# PLANNING AND ZONING DEPARTMENT STAFF REPORT - PAGE 1 OF 3

**PROJECT:** HURRICANE COFFEE

# **MEMORANDUM**

Goose Creek Time to Shine – at St. James Av. And Plantation North

Roadside Sign Location (Option C): Sign has been moved back to 22.5' from curb so it is out of the sight triangle per recommendations from Goose Creek Planning Department Staff.

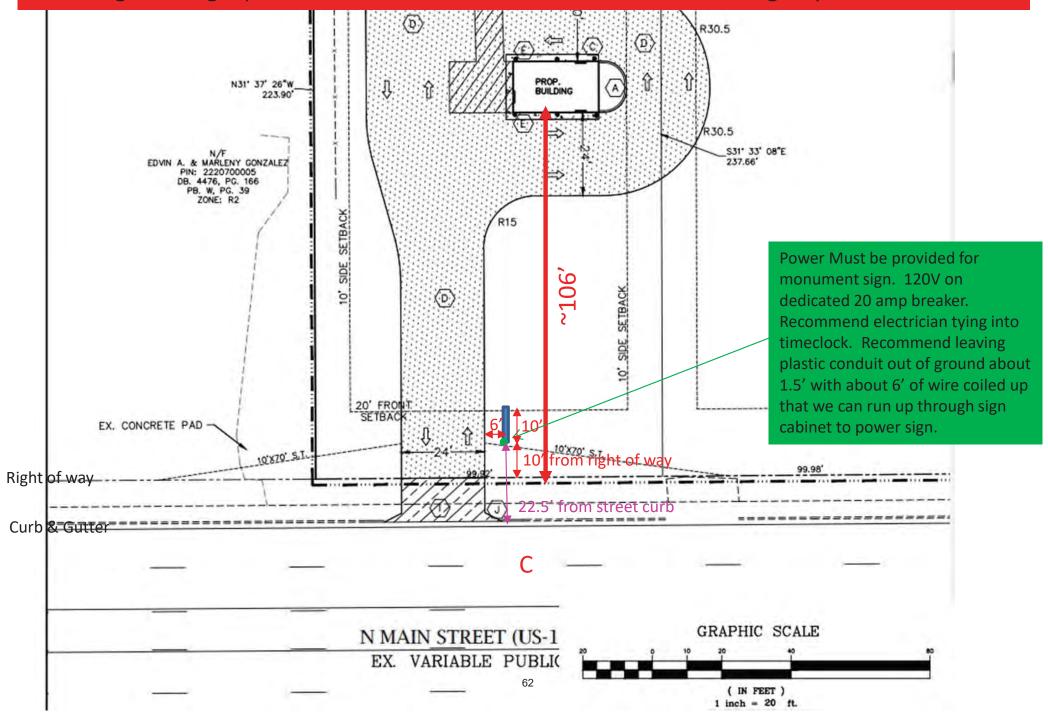
At the August 16<sup>th</sup> meeting of the ARB, they reviewed the sign permit for this location. The Board requested the applicant come back with a modified design and relocate the monument sign as this posed a line of vision issue for customer's existing the site. Other considerations of the signs include but are not limited to:

C1 ST. JAMES AVENUE SITE ELEVATION

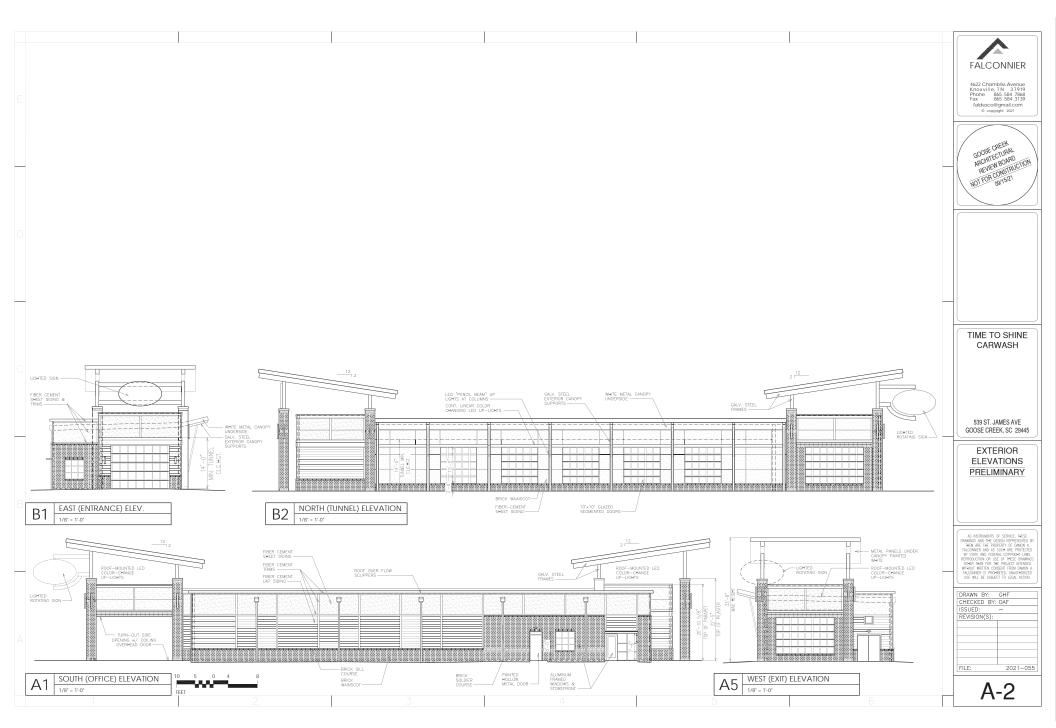
- Windows along St. James ARB concerned regarding lighting within the carwash creating a vehicular visual disturbance. Staff recommends Bahama shutters at each opening over the raised garage doors in lieu of the metal canopy that runs along the fascia on the St. James Side.

- The Board was very pleased with the Savannah Hwy. elevation. Staff recommends the brick columns and continuous roofing mimic that of the Savanah Hwy. location.

- Landscaping Staff recommends incorporating Palm trees at each brick column on the St. James side and at the canopies covering the vacuum areas. Also, a color rendering for the Landscape plan and elevations updated with revised landscaping.
